GRIMES FAMILY SUBDIVISION I

APPLICATION NUMBER 10 DATE June 3, 2010

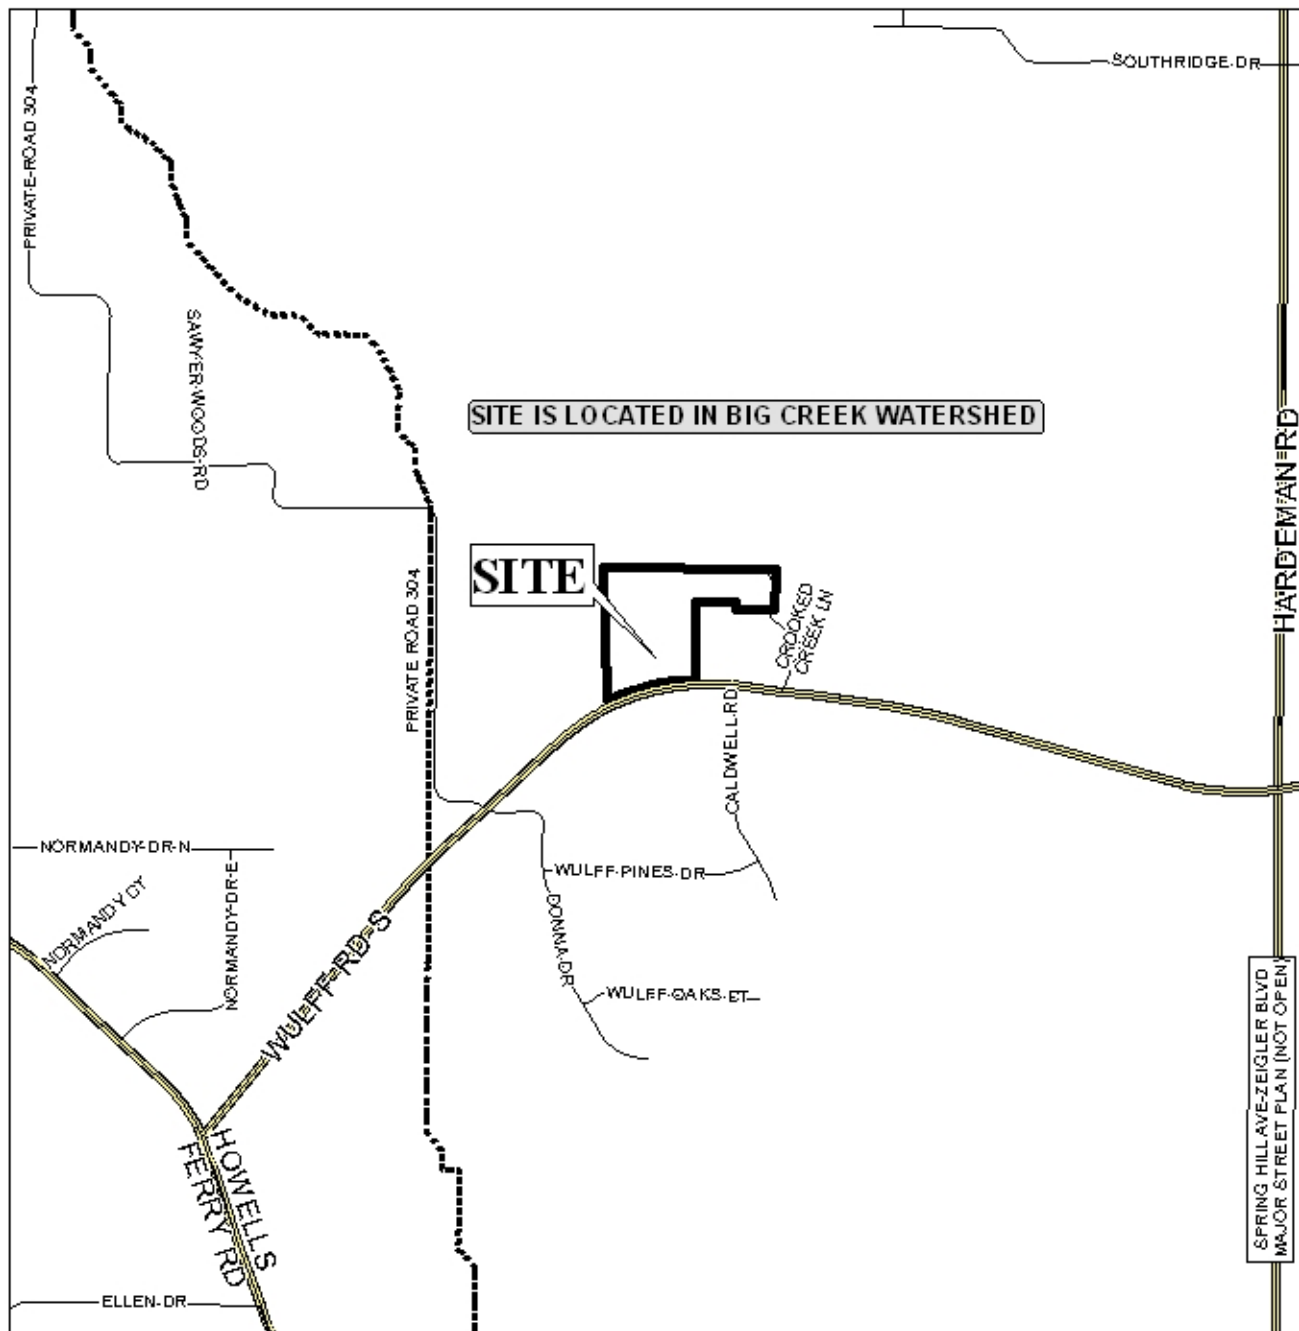
The plat illustrates the proposed 9.6± acre, 3 lot subdivision, which is located on the North side of Wulff Road South, 200'± West of the North terminus of Caldwell Road – within the planning jurisdiction. The applicant states that the site is served by public water and individual septic tanks.

The purpose of this application is to create three lots of record from three metes and bounds parcels. It should be noted that the larger parcel, Tax Parcel R022409290000009., has several child parcels, all created without going through a legal subdivision process. Typically, all parent and child parcels are required to be included in subdivision processes; however, at the time that most were created, they were not subject to the City's Subdivision Regulations. In fact, before the 2008 annexation, the subject area was within the jurisdiction of the County, under which the creation of parcels equal to or greater than 5 acres in size, or in cases of family subdivisions (as is the case at hand), is exempt from the subdivision process. Then just recently, after expansion of the City's Planning Jurisdiction, the subject parcels were created; hence this application. Additionally, the applicant states that there is an error in the plat as submitted; Tax Parcel R022409290000009 is to be included as Lot C. Fees have already been paid for the third lot, along with notification. As a condition of approval, the applicant should revise the final plat accordingly. The applicant should also revise the plat to label the proposed "parcels" as "lots."

The site fronts Wulff Road South with 80' of right-of-way. It should be noted that this section of Wulff Road South is part of the *Wulff Road (Wulff Road-New Connection)* thoroughfare on the Major Street Plan, which requires 100' of right-of-way. In small residential subdivisions, such as the one proposed, the Commission has at times allowed increased building setbacks to bypass

the requirement of dedication. Therefore, the applicant should revise the plat to depict a 35' building setback line from the existing right-of-way of Wulff Road South.

Proposed Parcels A, B and C have approximately 186' 223' and 55' of frontage, respectively, along Wulff Road South. As a means of access management, a note should be placed on the final plat stating that each lot is limited to one curb cut to Wulff Road South, with the size, location, and design to be approved by County Engineering and in conformance with AASHTO standards.

As proposed, Parcel C is considered a flag lot. Section V.D.1 of the Subdivision Regulations states that flag lots shall generally not be allowed, but may be permitted in certain circumstances. As already mentioned, the proposed lots will be owned (as are all other associated child parcels) by immediate family members of the applicant. Furthermore, there is a similar flag lot directly across Wulff Road South from the subject site (Lot 1 Carolyn Griffin Subdivision – approved by the County). Both situations provide some justification for approval. However, given its limited frontage, a note should be placed on the final plat stating that no future subdivision of Parcel C will be allowed until additional frontage on a public street is provided. Furthermore, the minimum building setback line for this lot shall be from where the “pole” meets the “flag” portion of the lot, and as Parcel C is large enough to subdivide, the pole must be at least 50' in width to allow for the construction of a public street at some future date, per Section V.D.1 of the Subdivision Regulations. It should be further noted that the existing landlocked parcels will not be affected by the subdivision.

The plat meets the minimum size requirement for developments with access to public water and individual septic tanks. However, it is requested that the applicant revise the preliminary plat to label the lots with their sizes in square feet (in addition to acreage), or provide a table on the plat with the same information.

- 1) revision of the final plat to include Tax Parcel R022409290000009. as Lot C;
- 2) rename “parcels” as “lots;”
- 3) depiction of a 35’ minimum building setback line from the existing right-of-way of Wulff Road South (this line on Lot C shall be from where the “pole” meets the “flag” portion of the lot);

- 4) placement of a note on the final plat stating that each lot is limited to one curb cut to Wulff Road South, with the size, location, and design to be approved by County Engineering and in conformance with AASHTO standards;

- 5) ensure that the pole of Lot C is at least 50’ in width for its entirety, as required by Section V.D.1 of the Subdivision Regulations;
- 6) placement of a note on the final plat stating that no future subdivision of Lot C will be allowed until additional frontage on a public street is provided;

- 7) labeling of the lots with their sizes in square feet (in addition to acreage) or the provision of a table on the plat with the same information;
- 8) placement of a note on the plat stating that approval of all applicable Federal, state and local agencies is required for endangered, threatened or otherwise protected species, if any, prior to the issuance of any permits or land disturbance activities;
